Facility Name: Fort Bliss Municipal Solid Waste Landfill

SUBJECT: Response to TCEQ Technical Review Comments
Fort Bliss Landfill, MSW Permit No. 1422
RN100210095/CN600126262; TCEQ Tracking No. 27754305

Response to Comments Matrix - TCEQ Technical Review Comments Dated September 19, 2022 and December 6, 2022
Notice Permit Modification Application Dated July 11, 2022
Fort Bliss Landfill (MSW Permit No. 1422), El Paso County Texas
TCEQ Tracking No. 27754305

FIGURE 1

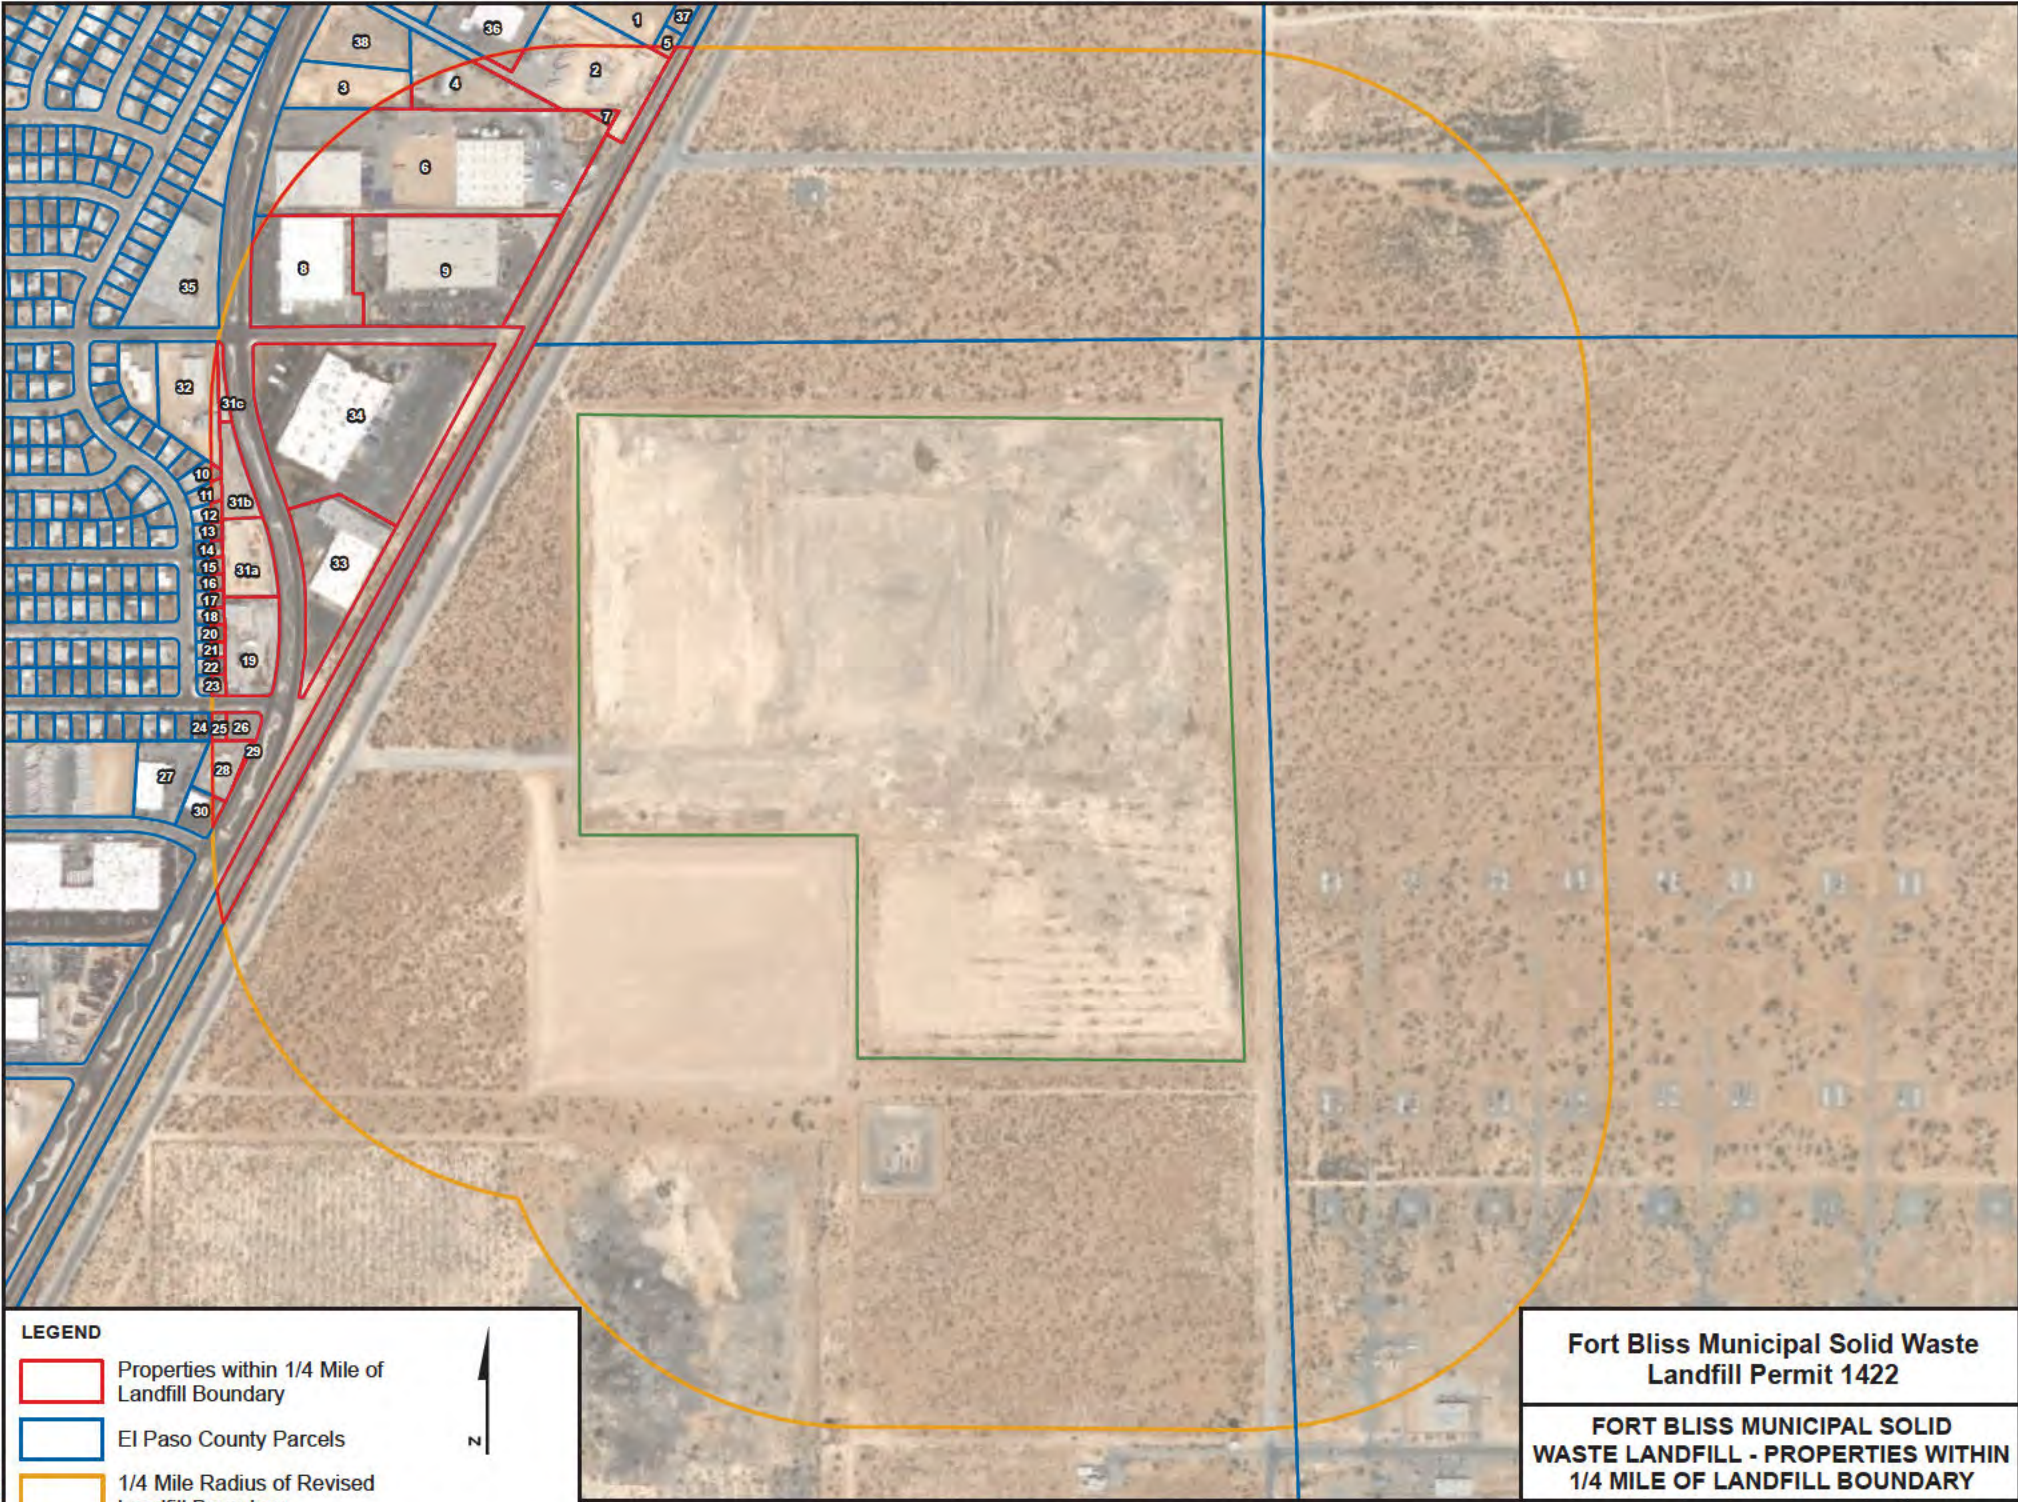
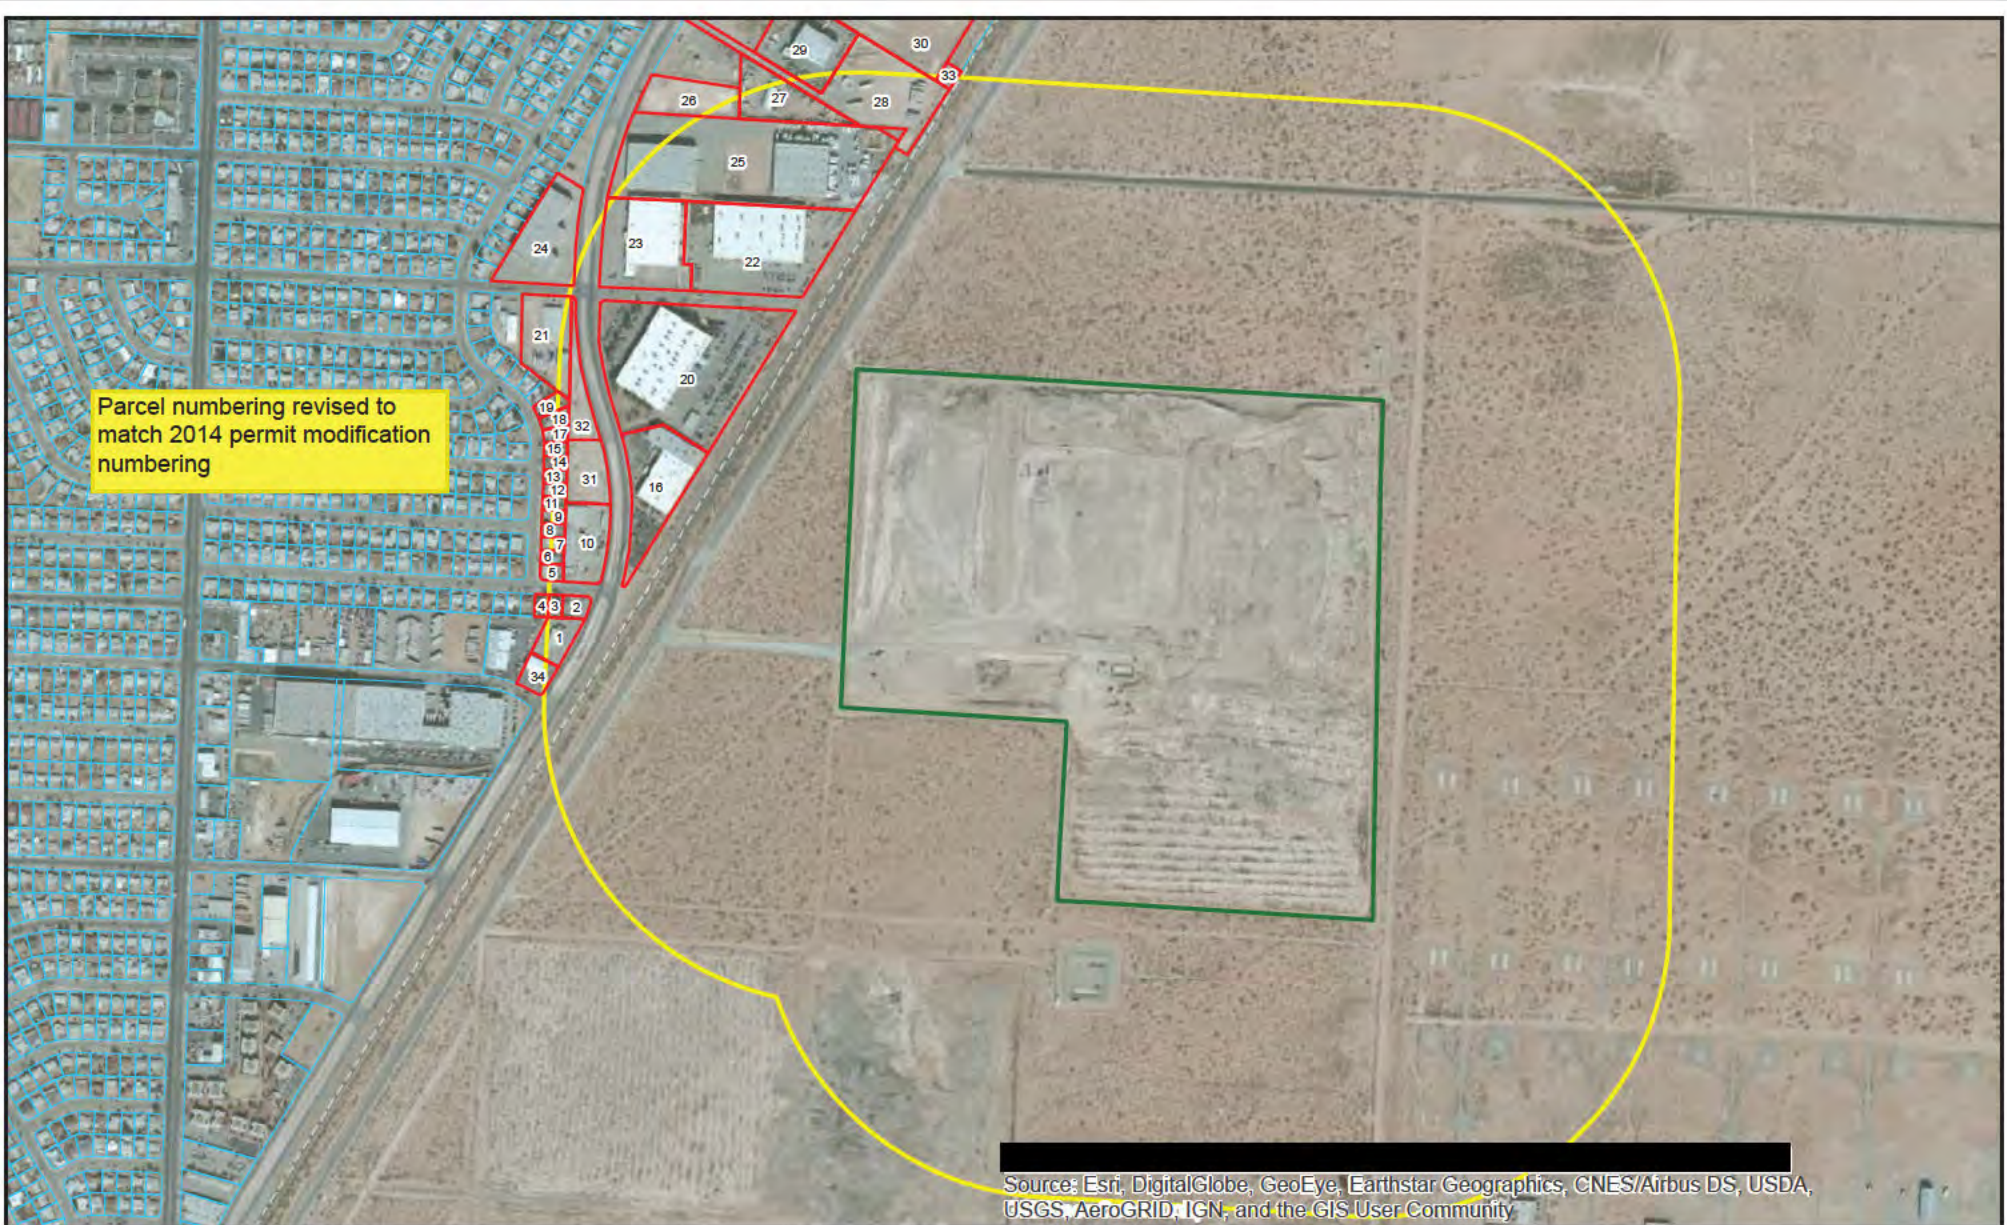
Comment #	TCEQ Comment:	Response:
3	Please provide the responsible engineer's seal, signature, and date for the revised land ownership map, Figure 1 – Fort Bliss Municipal Solid Waste Landfill-Properties Within ¼ Mile of Landfill Boundary	Figure 1 – Fort Bliss Municipal Solid Waste Landfill-Properties Within ¼ Mile of Landfill Boundary has been sealed and includes the responsible engineer's seal, signature, and date for the revised map. Attachment 5b_Comment 3 contains the sealed version of Figure 1. The sealed Figure 1 page replaces the one presented in Attachment 4b .
4	Please provide a revision date for the a) title page of revised Appendix B, Landfill Modification and Closure Design Drawings and for the b) Table of Contents – List of Drawings of Appendix B. Please also ensure the responsible engineer's seal, signature, and date are also on the updated title page and Table of Contents.	The title page and the Table of Contents (List of Drawings) for Appendix B (Landfill Modification and Closure Design Drawings) have been revised to include revision dates. The responsible engineer's seal, signature, and date are also included on the updated title page and Table of Contents. Attachment 5c_Comment 4 contains the revised Appendix B title page and Table of Contents.

Table revised to match numbering revisions on the Landowner's Map
